STAFF REPORT
(One-Step Final Plat)

CASE NUMBER: SUB 2000-61 -- WOODLAND GLEN 2ND ADDITION

LOCATION: West of Arkansas, South side of 32nd St. North

VICINITY MAP

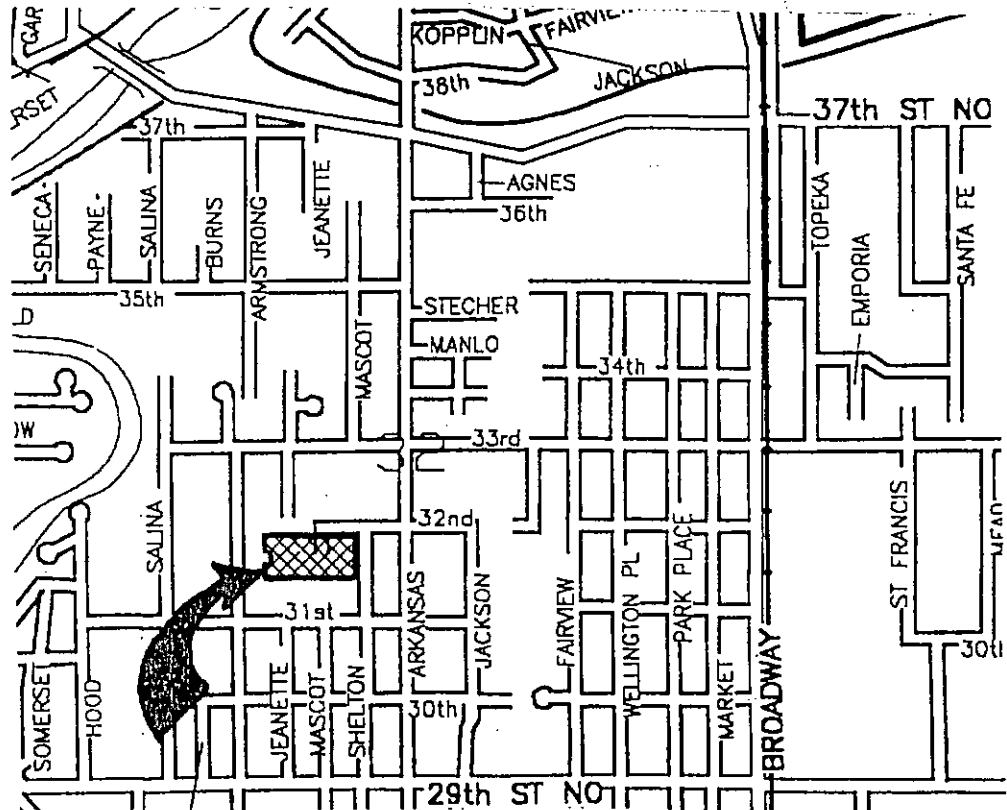
- C. City Engineering needs to comment on the status of the applicant's drainage plan.
- D. The applicant shall participate in the petition for the paving of Mascot Avenue.

- E. The applicant shall dedicate the south half of 32nd St. and participate in the petition for paving; or in the alternative, the Applicant shall submit a request for vacation. If a vacation request is submitted, a 90-ft segment of 32nd Street shall be retained to allow for a "T" turnaround for Jeanette.

- F. A turnaround for Jeanette is needed along the south line of the plat.
- G. A 60-ft wide continent dedication of right-of-way should be platted for the extension of Jeanette, along with 25-ft building setback lines in order to allow for future development of urban-scale lots.
